UNITED STATES PATENT AND TRADEMARK OFFICE

APPLICATION NO.	FILING DATE	FIRST NAMED INVENTOR	ATTORNEY DOCKET NO.	CONFIRMATION NO.
10/709,580	05/14/2004	Paul K. MEEKER	43064-0030	3579

Office Action Summary	Application No.		Applicant(s)	
	10/709,580		MEEKER ET AL.	
	Examiner		Art Unit	
	Joseph F. Edell		3636

Diagram A - Annotated Figure 8 of Burleigh et al.

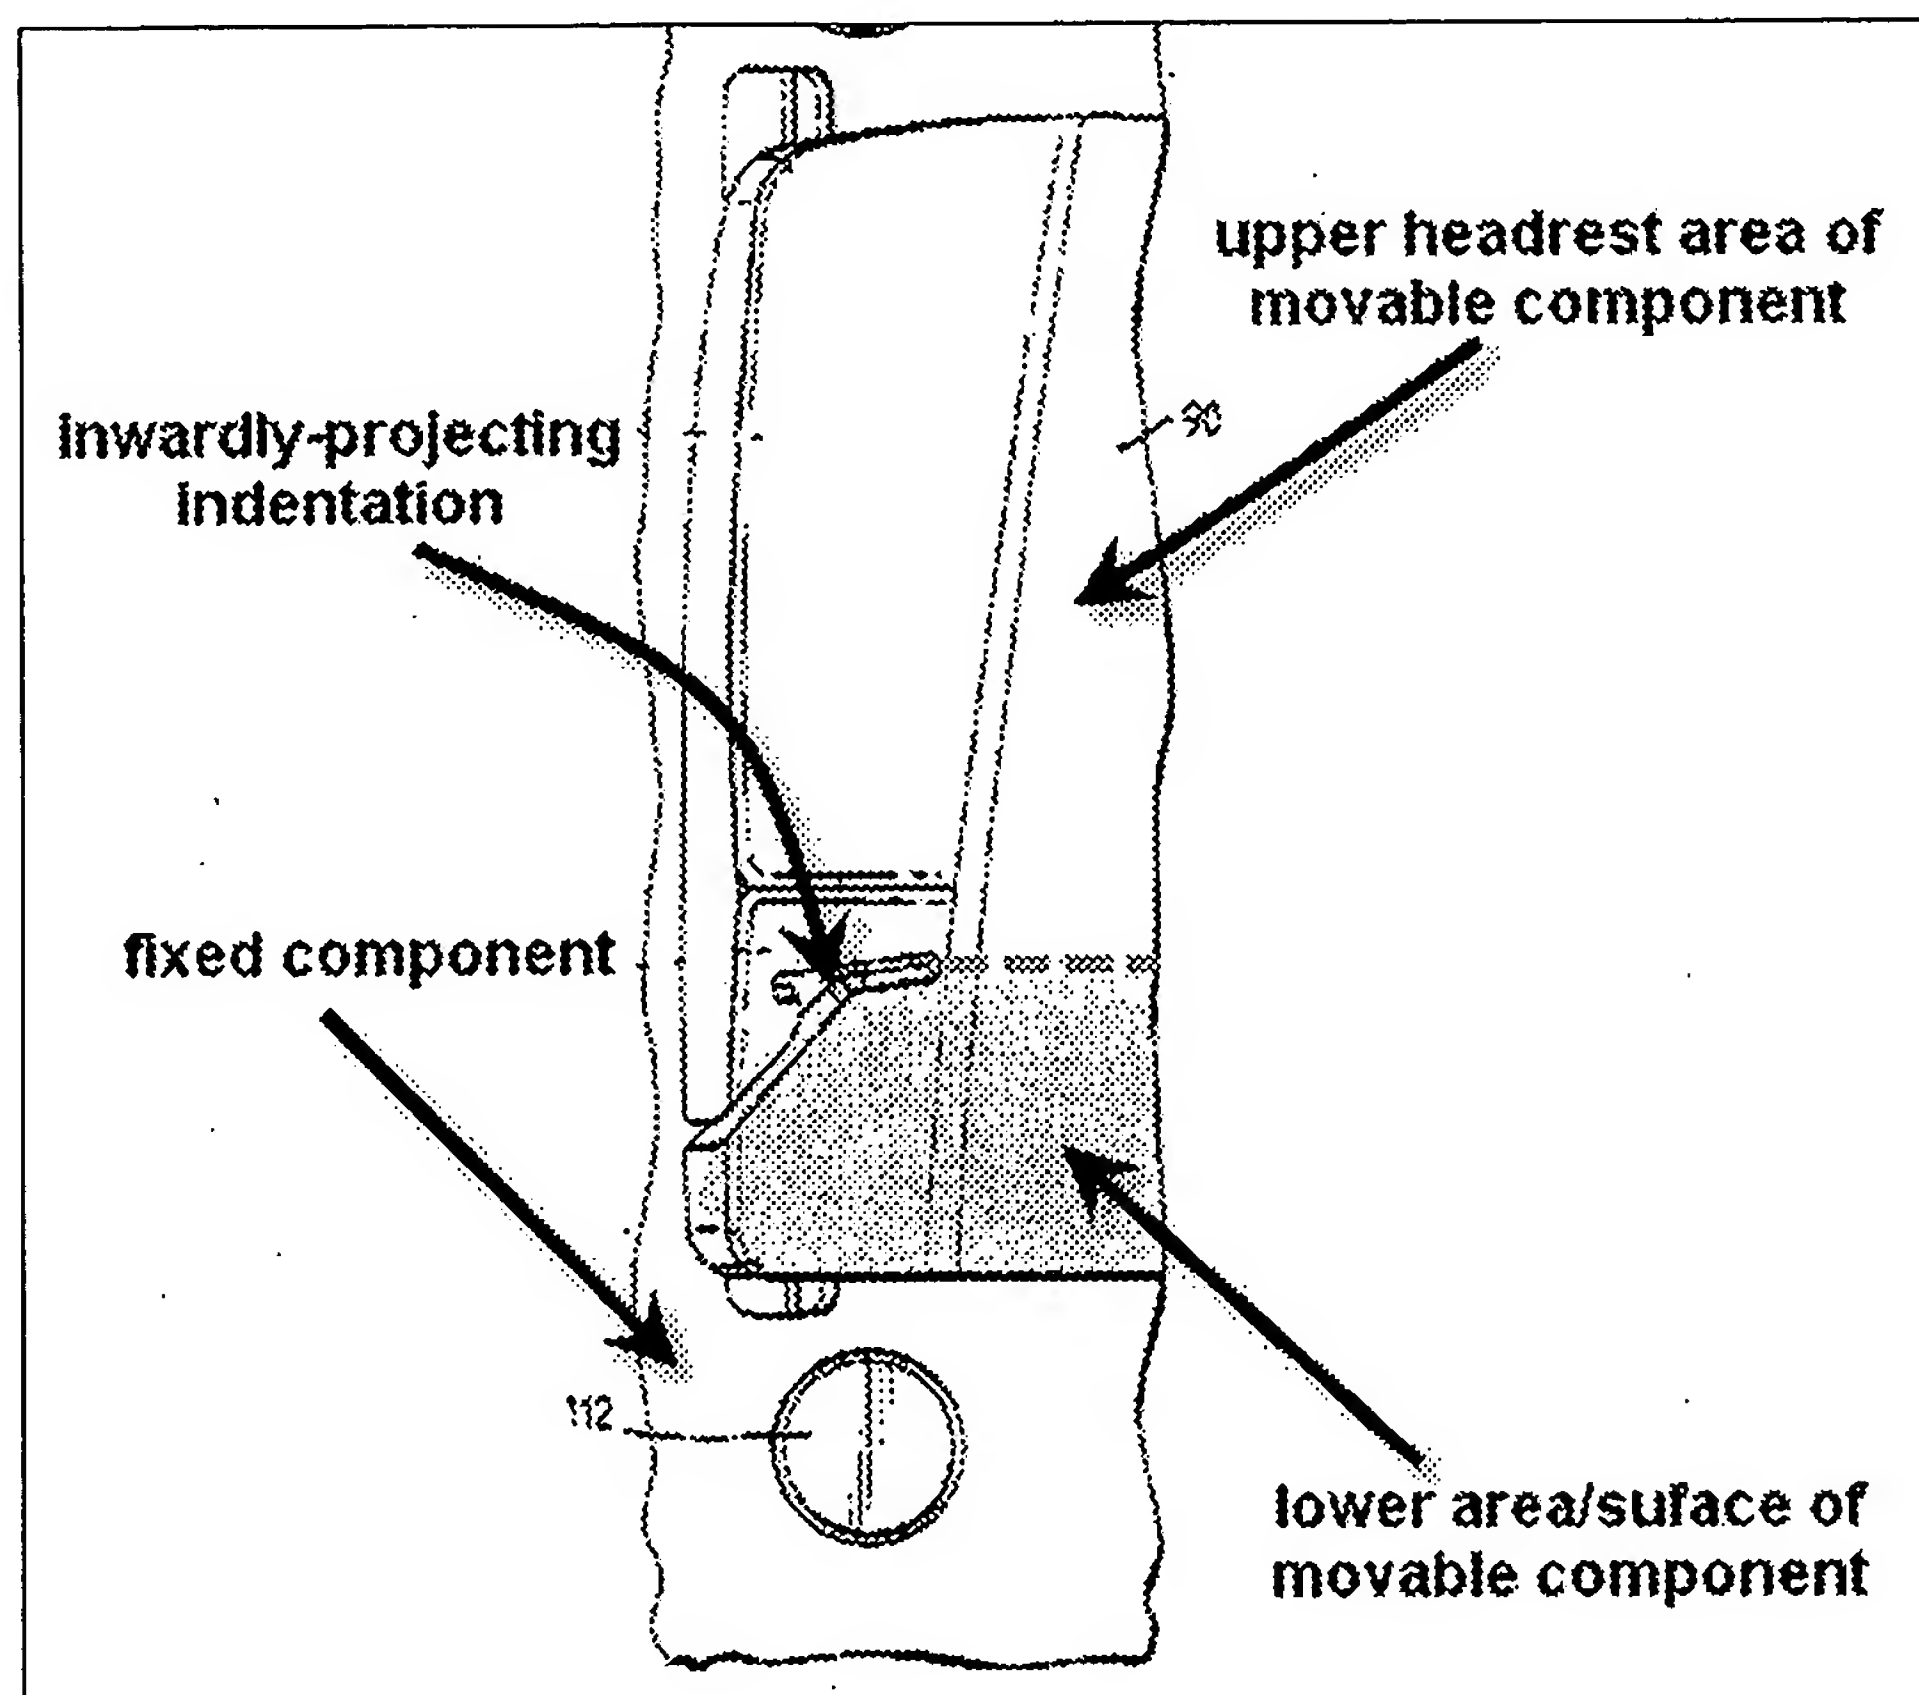
Burleigh et al. disclose a car seat that includes all the limitations recited in claims 1-5, 7, 8, 10-20, 22-27, 29, 30, 32, and 38-40. Burleigh et al. show a seat having a seat member 72 (see Fig. 5), a back member 78 connected to the seat member, a fixed component (see Diagram A below) of the back member including a flat middle section, a pair of raised contoured sides 80,82 (see Fig. 6), and a contoured surface in cross-section, a movable component 90 of the back member including raised contoured sides 92,94, capable of movement from a retracted position to an extended position, and overlapping the fixed component, an upper headrest area of the movable component (see Diagram A) with a flat middle section, a pair of forward extending wings, and an upper headrest width, and an opposed lower area (see Diagram A) separated from the upper headrest area by a pair of fixed size laterally and inwardly-projecting indentations 126,128 (see Fig. 8 and Diagram A) to accommodate a shoulder belt, fixedly connected to the upper headrest area, including a surface and a contour in cross-section mating the contoured surface of the fixed component, and a lower area width wherein the upper headrest width and the lower area width being essentially the same.

Burleigh et al. show a back member wherein the upper headrest area being in invariant fixed relationship to the lower area and separated by the indentations (see Diagram A), the movable component is attached in front of the fixed component, the fixed and movable components being in overlapping essentially gapless and contacting relationship with respect to each other with sliding movement between the components at both the retracted and extended positions (sliding movement of shoe parts 118 along tracks 96,98 - see Fig. 6 - allowing for the gapless relationship), the sliding movement

between the components does not increase a size of the indentations between the upper headrest area and lower area, and means for selectively positioning and retaining the movable component relative to the fixed components (the shoe parts and tracks are functionally equivalent to the positioning and retaining structure described in the instant application) that permits incremental discrete movement or infinitely variable movement and is a pair of outwardly biased shafts 118 capable of locking, and telescoping movement of the movable component relative to the fixed component which is fixed by a length of longitudinal channels 96,98 in the fixed component.

Edition. As the indentations (see Diagram A above) clearly are of the side of the upper headrest area, Burleigh teaches this limitation recited in claims 38-40.
